# ADDENDUM NO. 1

**April 29, 2022**

**NEW ADMINISTRATION CENTER, ALTERNATE EDUCATION AND  
RESOURCE CENTER AND RELATED WORK PROJECT  
Crown Point, IN 46307**

This Addendum forms a part of and modifies the Bidding Requirements, Contract Forms, Contract Conditions, the Specifications, and the Drawings dated April 15, 2022 by Gibraltar Design. Acknowledge receipt of the Addendum in the space provided on the Bid Form. Failure to do so may subject the Bidder to disqualification.

DRAWING  
DETAILS

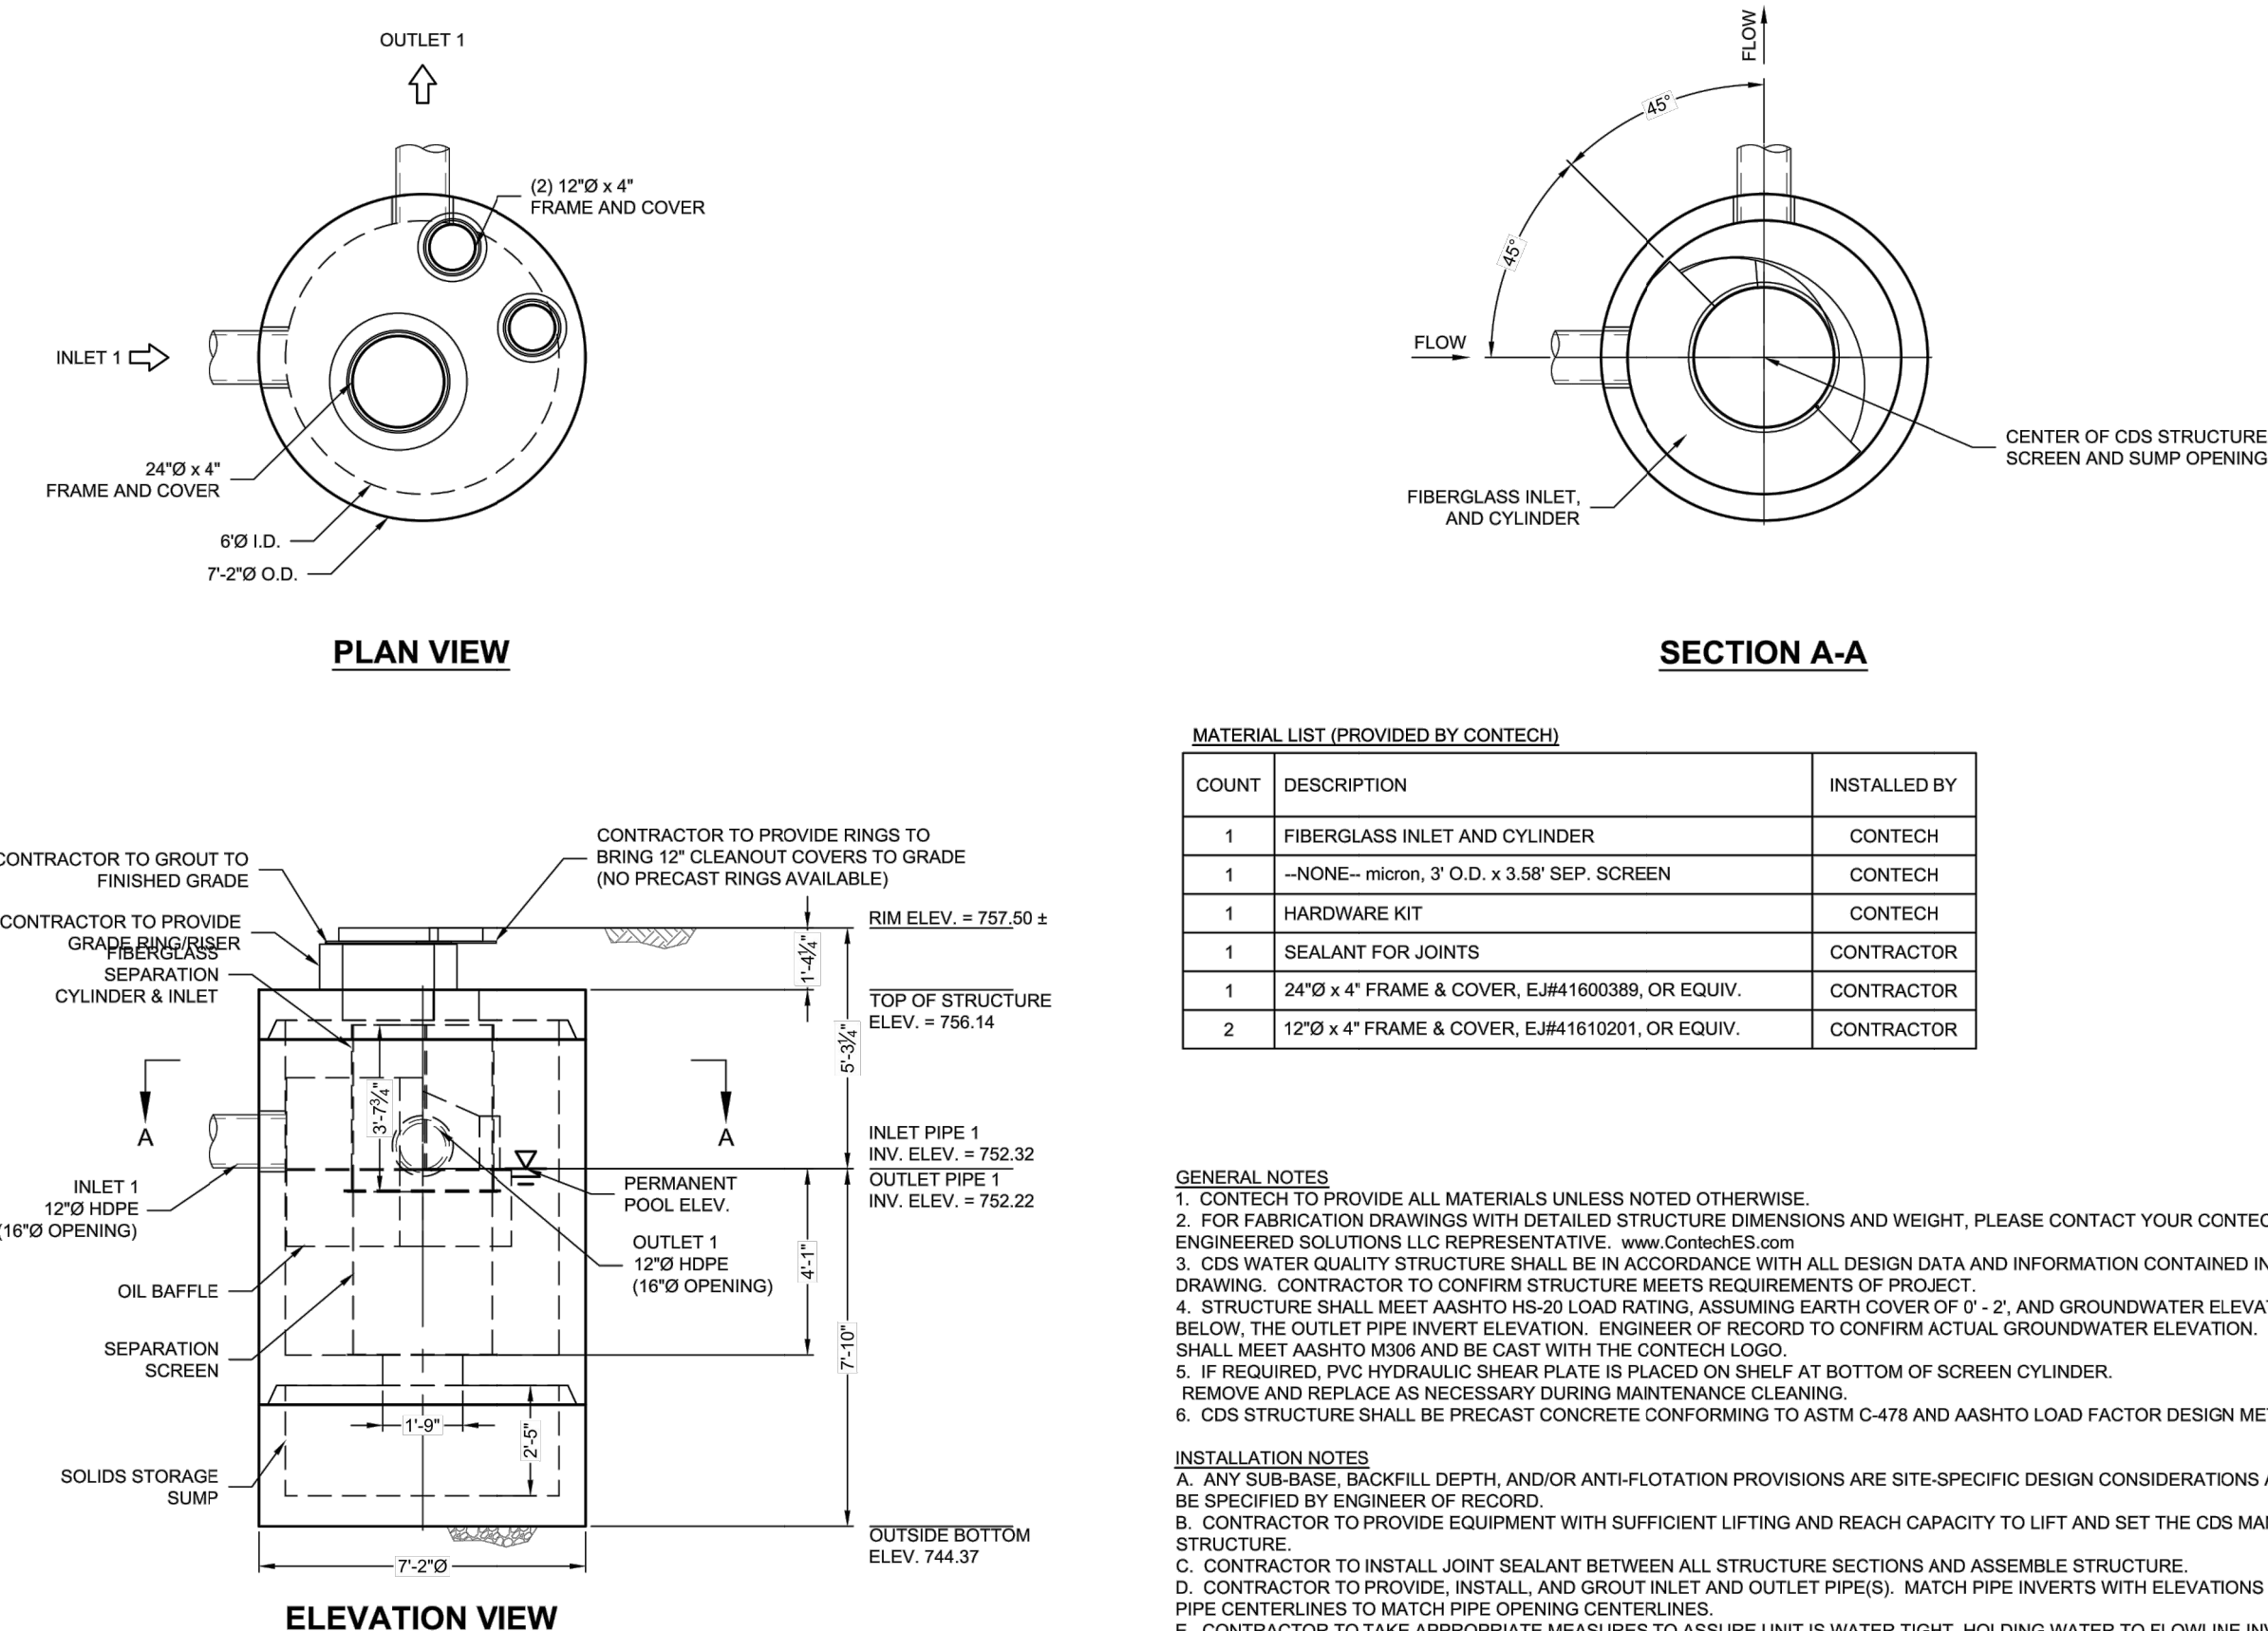
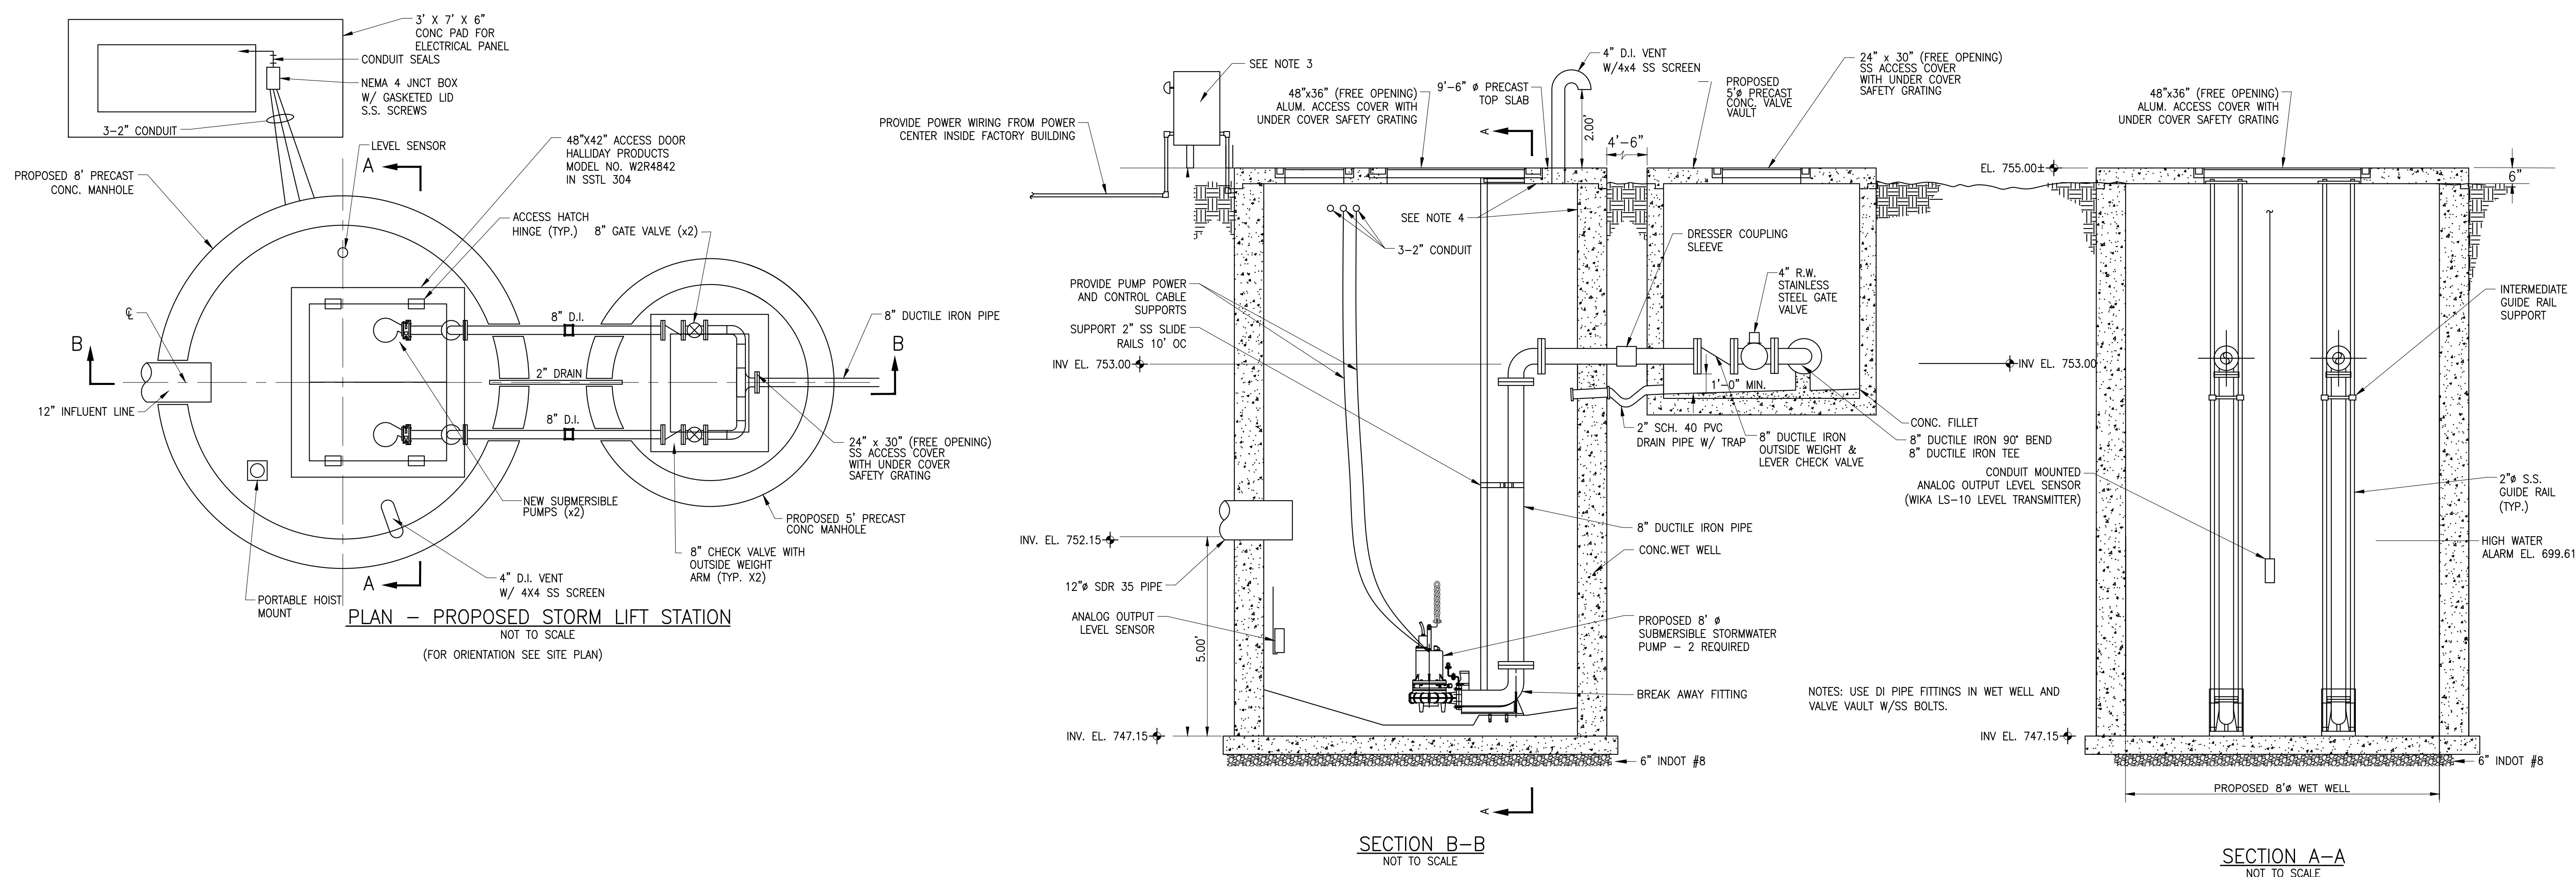
**5. Sheet C-115**

- A. Refer to revised, full size drawing, included in this Addendum, for the following revisions:
1. Add "CDS3035-6-C-707498-10 Hydrodynamic Separator" detail.
  2. Add "Frame and Cover Notes" section regarding the hydrodynamic separator structure castings to be used.

1. "CDS3035-6-C-707498-10" HYDRODYNAMIC SEPARATOR STRUCTURE DETAIL HAS BEEN ADDED.
2. "FRAME AND COVER NOTES" REGARDING THE HYDRODYNAMIC SEPARATOR STRUCTURE CASTINGS HAVE BEEN ADDED.
